Proposed Doors to Third Floor &
'Town Bar' Walls Paint & Fireplace Facing,
'The Norfolk Arms' Hotel, Arundel.
for
The Norfolk Arms Hotel

PROPOSED - THIRD FLOOR
New & Replacement Doors Elevations

DATE: FEB. 2018
SCALE: 1:20 @ A1
DRAWN: AEC
DRWG. NO. 329/32
REVISION:

# THIRD FLOOR REPLACEMENTS
# Bedroom Door ( A1 )

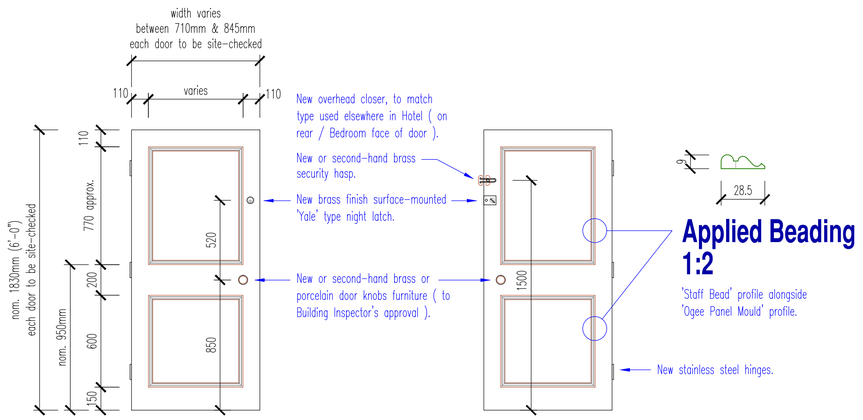
FULL PLANNING and LISTED BUILDINGS APPROVALS ref: AB/22/16/PL and AB/23/16/L INCLUDED FOR RETENTION & RE-USE OF EXISTING ROOM DOORS, WHICH WERE TO BE UP-GRADED TO PROVIDE AT LEAST 30-mins. FIRE-RESISTANCE.
AFTER WORKS COMMENCED, DOORS WERE FOUND TO BE POOR QUALITY, 2-PANEL TIMBER DOORS, WHICH WERE SUBSEQUENTLY CONDEMNED BY THE BUILDING INSPECTOR ( Timber stiles & rails sizes and panels thickness were not sufficient to provide any fire resistance, and damage found from historical ironmongery changes would not be able to be adequately repaired ).

Replacement proprietary 30-mins. rated fire-resistant doors & new frames, to suit existing doors openings and existing Corridor width, all with combined intumescant strips & smoke-seal brushes fully rebated into door leafs edges.
Flush-faced door 'blanks', cut to size to suit as required - all with applied moulded hardwood beads on both faces of door, to resemble original 2-panel door appearance.
All with gloss-paint spec. finish, to match existing doors colour elsewhere in hotel.

3no. REPLACEMENT BEDROOM/CORRIDOR DOORS TOTAL, APPLICABLE TO:-
GUEST BEDROOMS 25, 26 and 27.

# NEW & REPLACEMENT THIRD FLOOR DOORS
# Cross-Corridor Doors B1 and B2

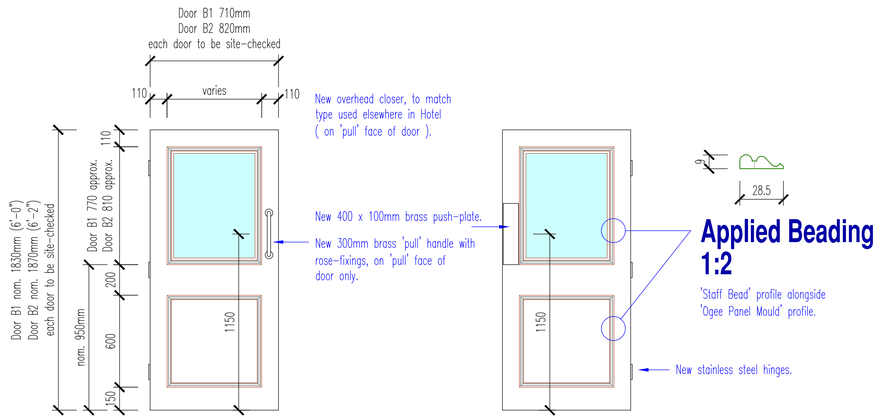
DOOR B1:-
- NEW DOOR & FRAME, REQUIRED BY BUILDING INSPECTOR and IS ADDITIONAL TO APPROVALS ref: AB/22/16/PL and AB/23/16/L.

DOOR B2:-
- TO REPLACE EXISTING DOOR BETWEEN CORRIDOR & STAIRWELL.
- EXISTING DOOR IS 1970's FULLY-GLAZED, WITH 10no. SMALL 'GEORGIAN-WIRED' PANES.
- REPLACEMENT DISCUSSED ON SITE WITH CONSERVATION OFFICER and IS ADDITIONAL TO APPROVALS ref: AB/22/16/PL and AB/23/16/L.

New proprietary 30-mins. rated fire-resistant door & new frame ( B1 ) and replacement 30-mins. rated fire-resistant door leaf only within existing frame ( B2 ), all with combined intumescant strips & smoke-seal brushes fully rebated into door leafs edges.
Proprietary semi-glazed timber doors, glazed with EITHER 'georgian-wired' glass OR 'Pyran' clear laminated intumescant glass, all with intumescant gaskets & timber glazing beads.
Doors with applied moulded hardwood beads on both faces of doors lower halves, to resemble appearance of 'fake' panels on adjacent Bedroom doors.
All with gloss-paint spec. finish, to match existing doors colour elsewhere in hotel.

2no. CROSS-CORRIDOR DOORS TOTAL:-
- NEW ADDITIONAL CROSS-CORRIDOR DOOR & FRAME B1
- REPLACEMENT DOOR ( between Corridor & Stairwell ) B2.
